City of Kingston
Report to Kingston Heritage Properties Committee
Report Number HP-24-043

Subject: Applications for Ontario Heritage Act Approval

Address: 411 Wellington Street (P18-520)

File Numbers: P18-095-2024, P18-096-2024, P18-097-2024, P18-098-2024, P18-099-2024 and P18-101-2024

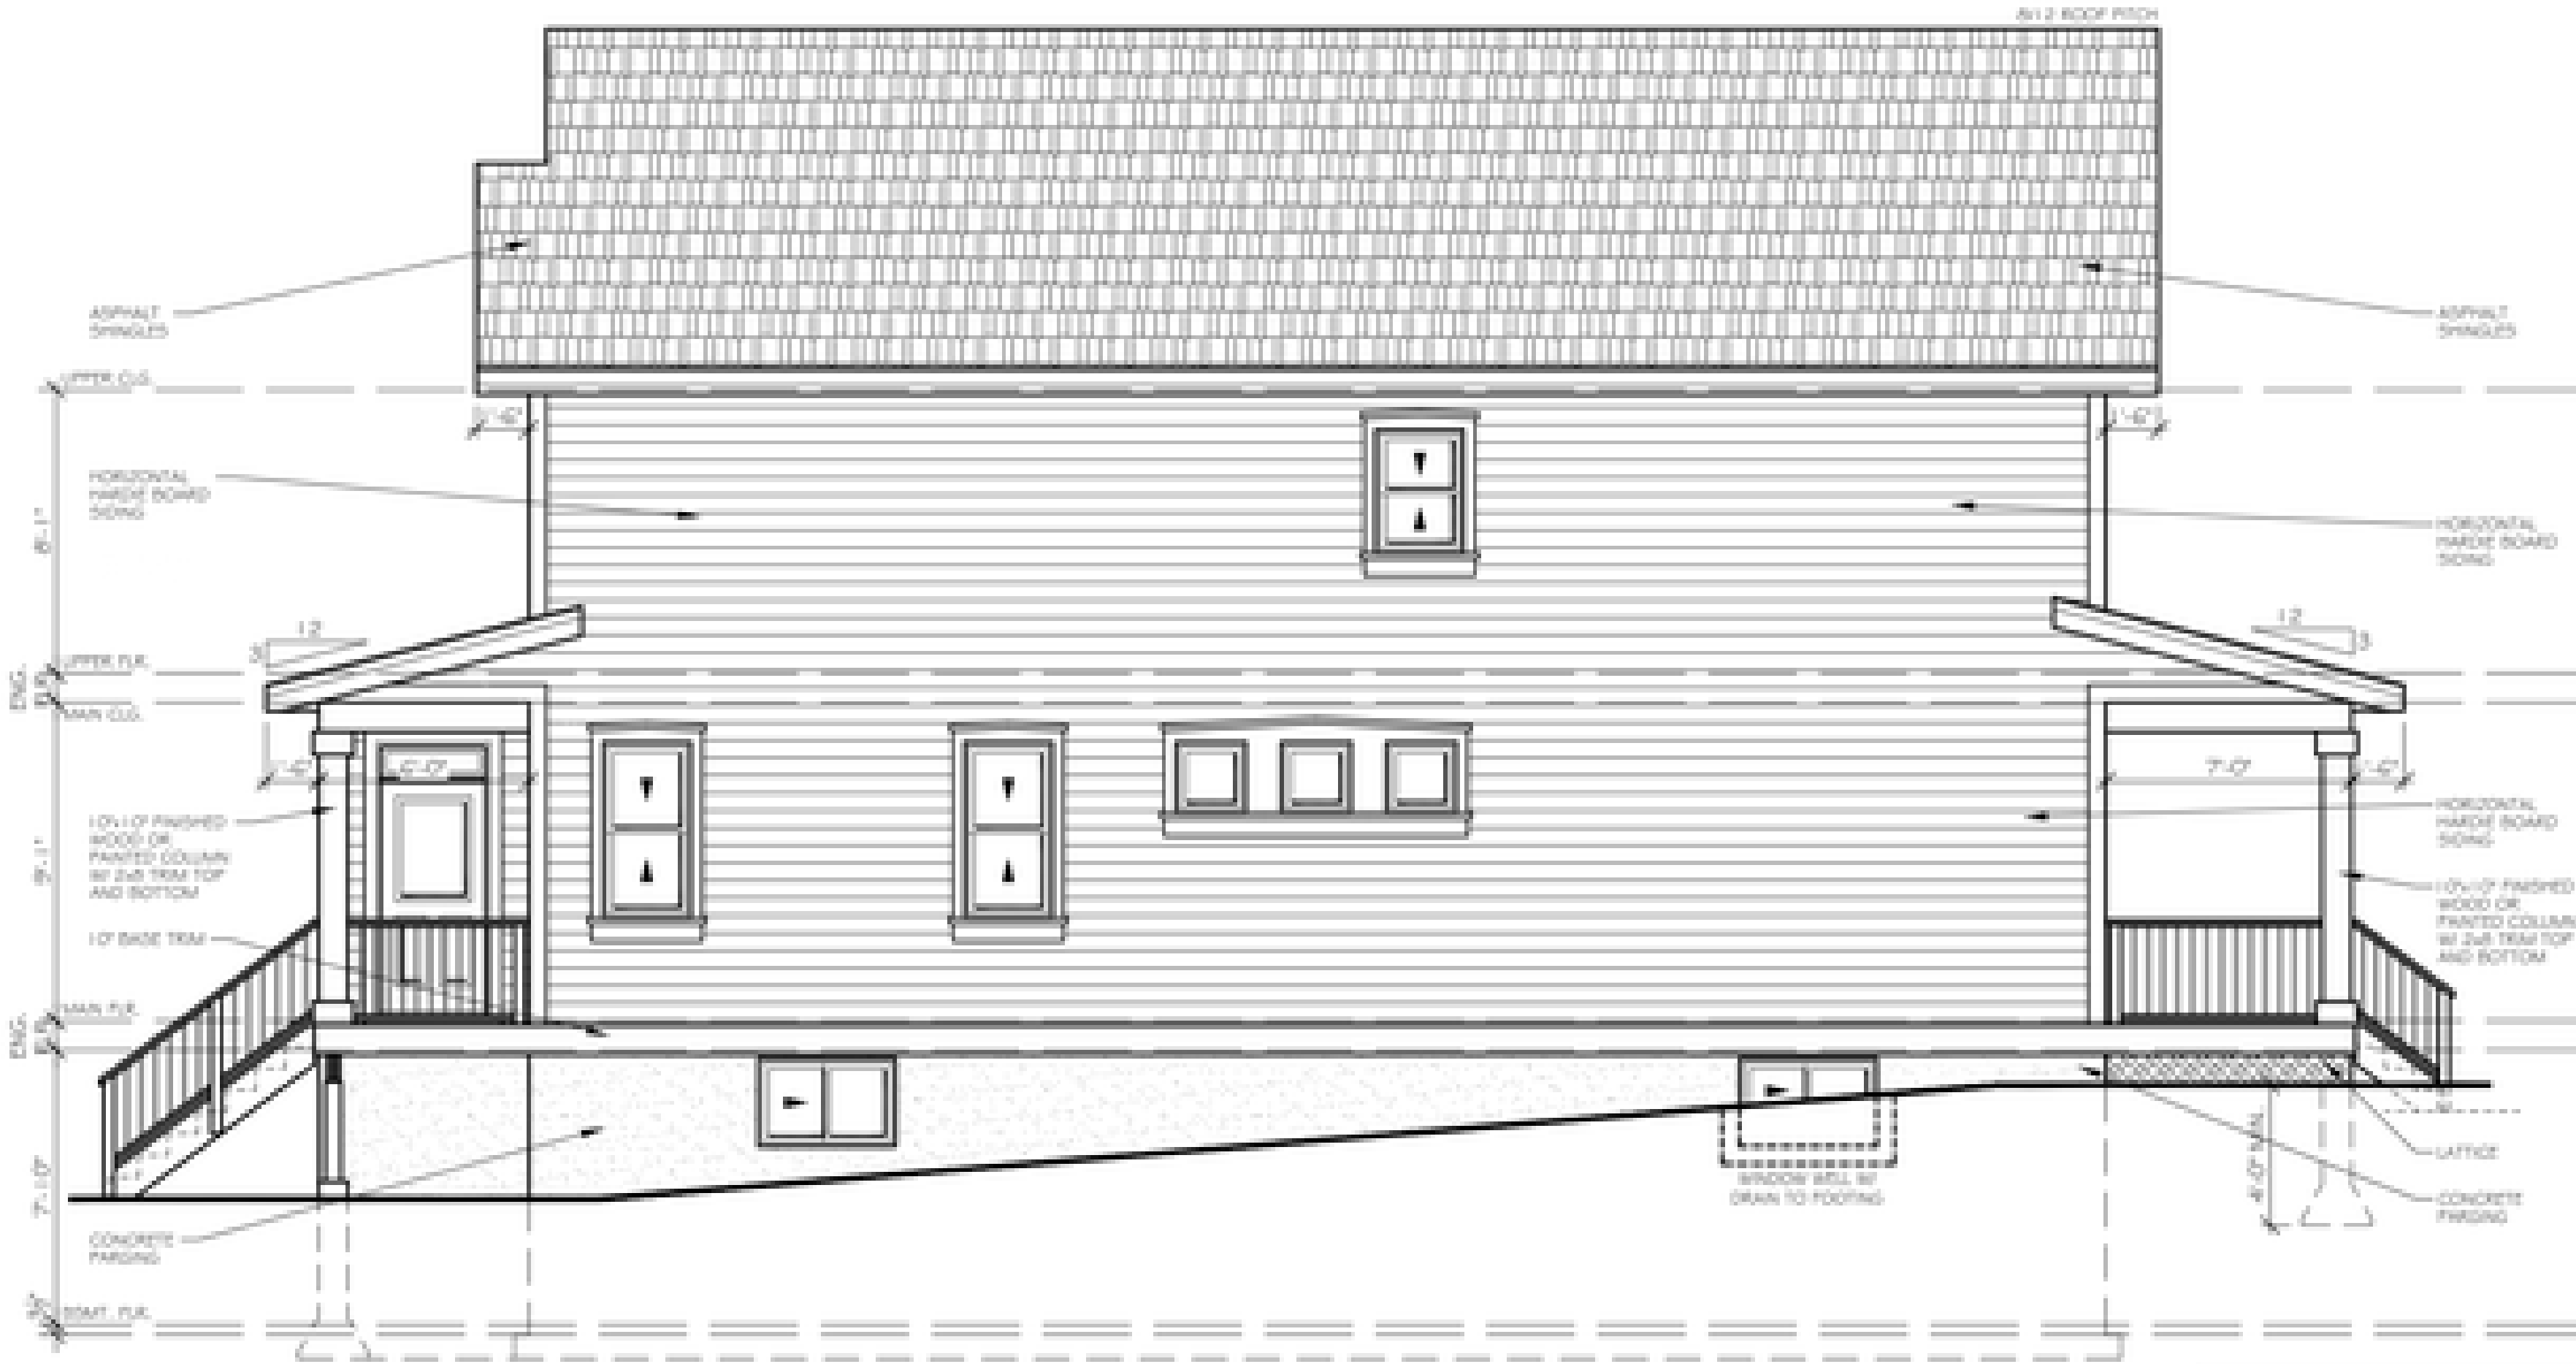
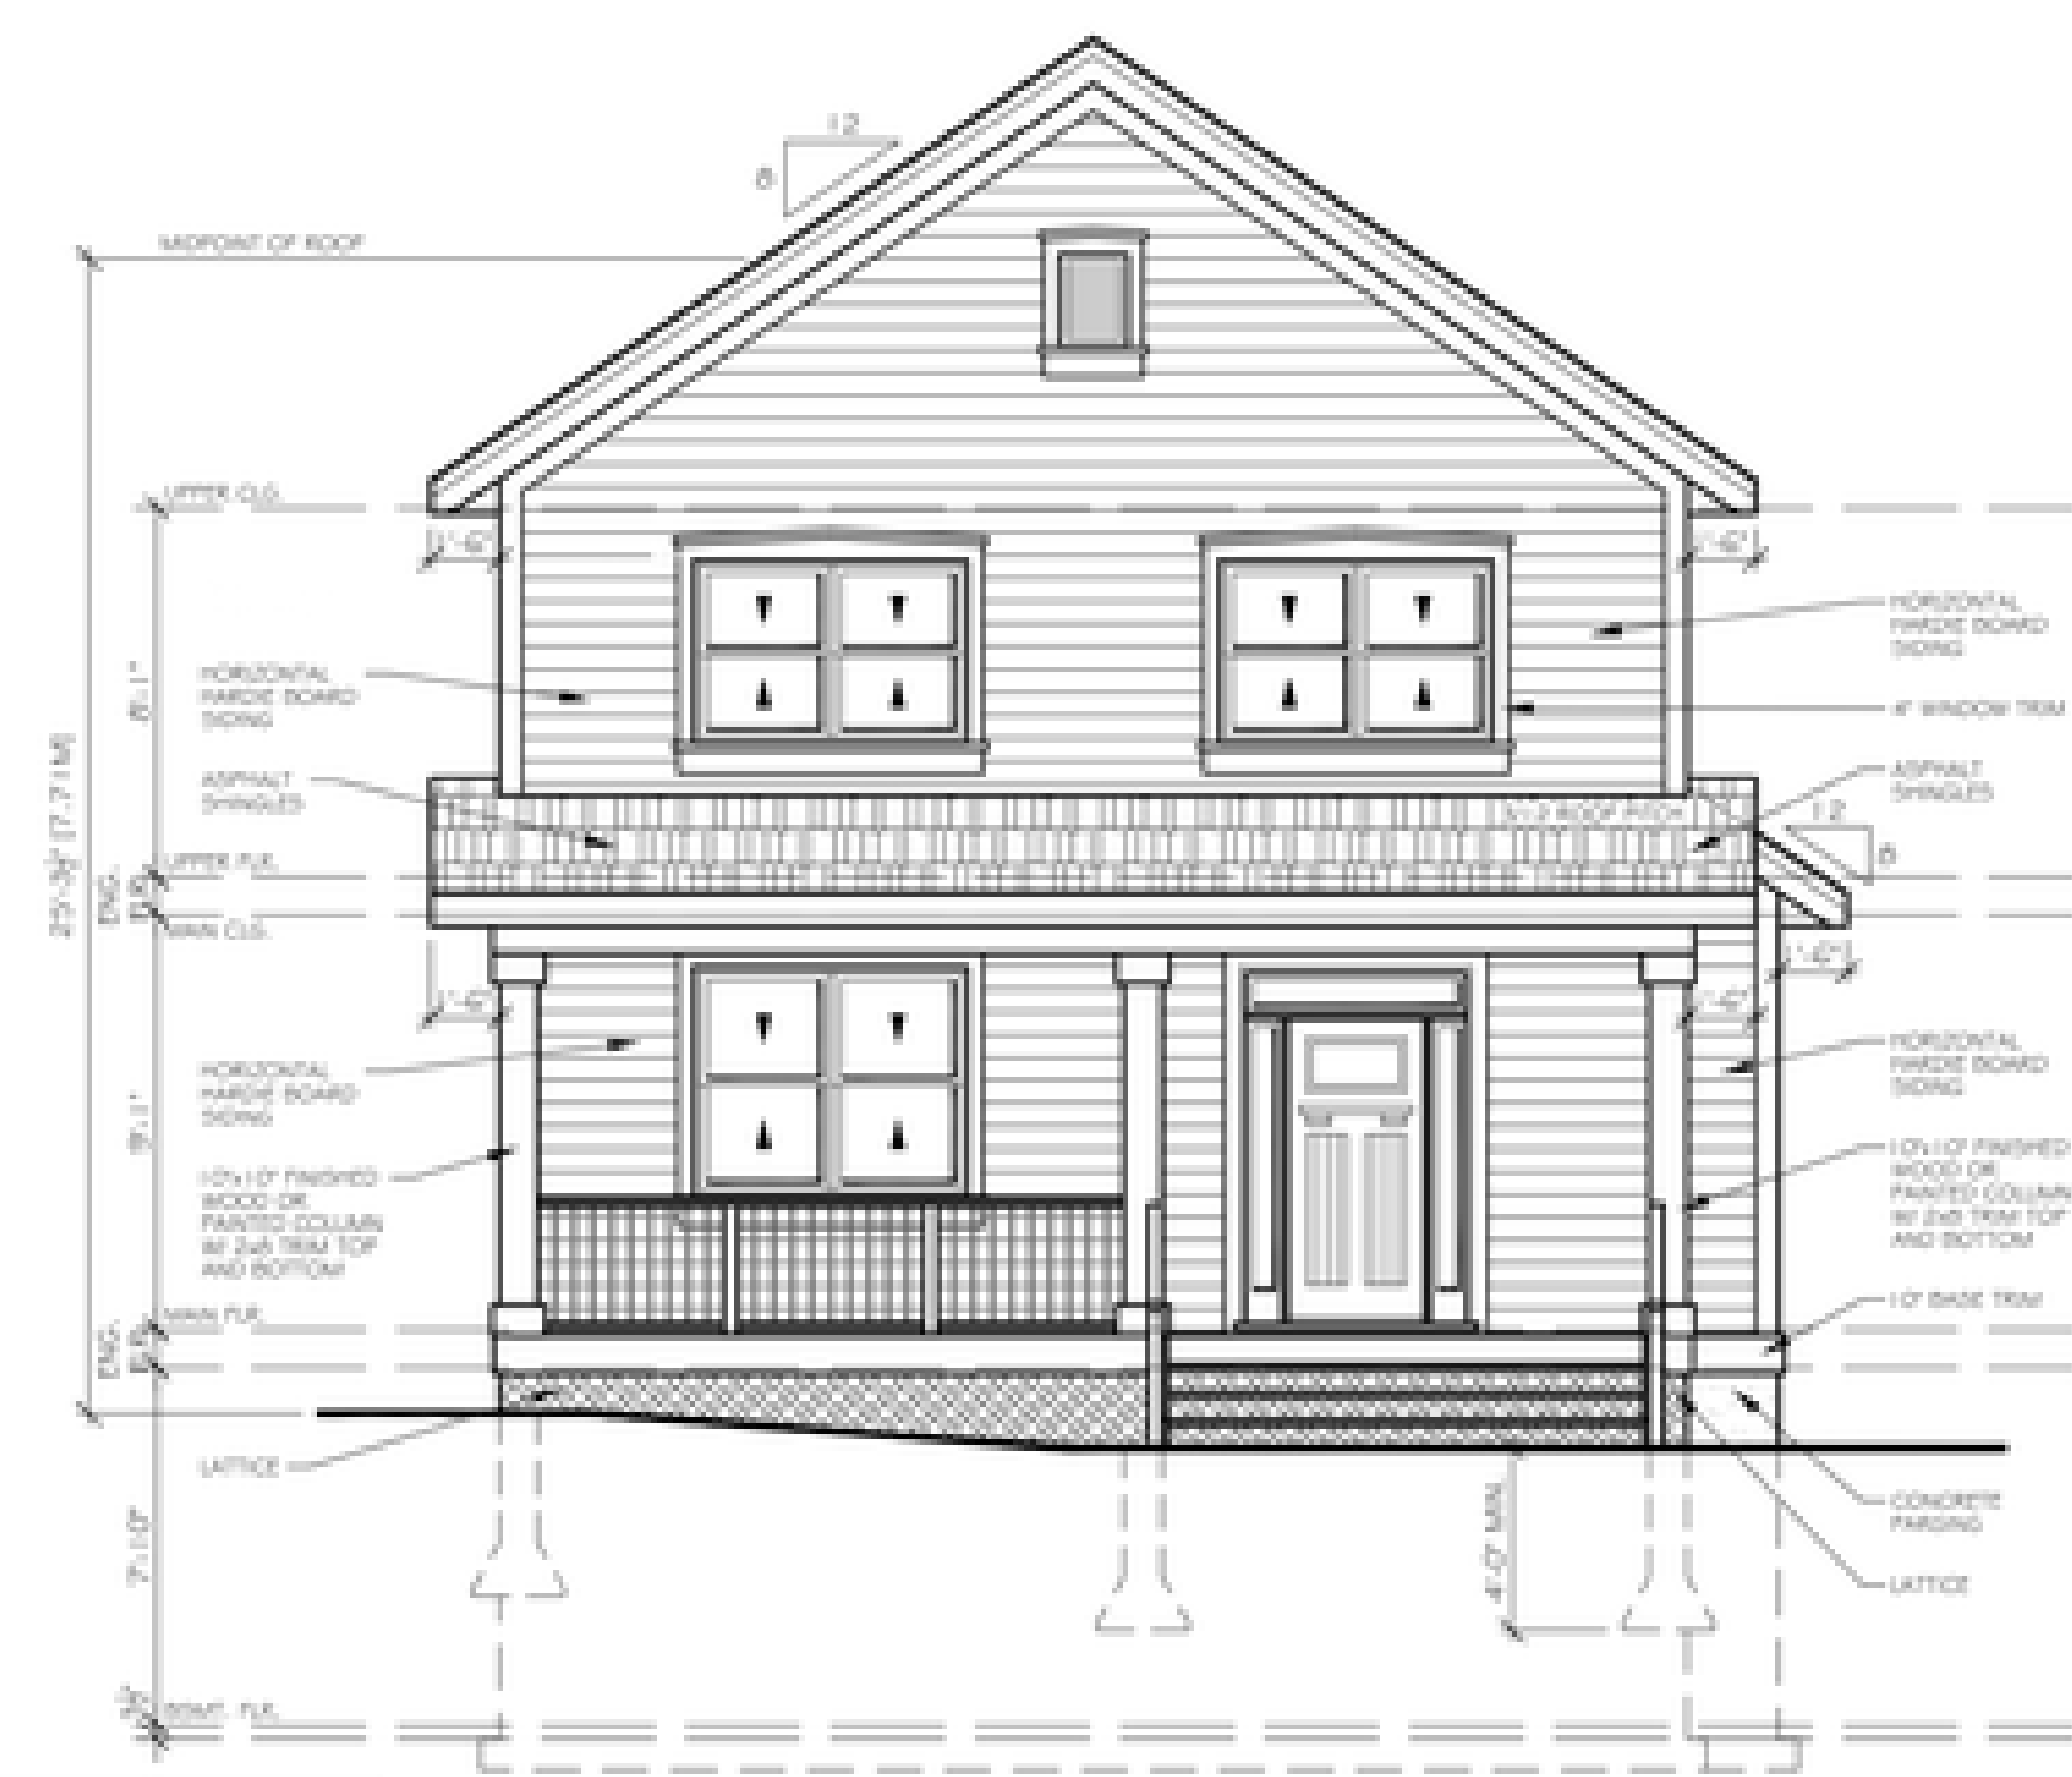
Change to reflect the prominent
vertical horizontal configuration
preference of the district
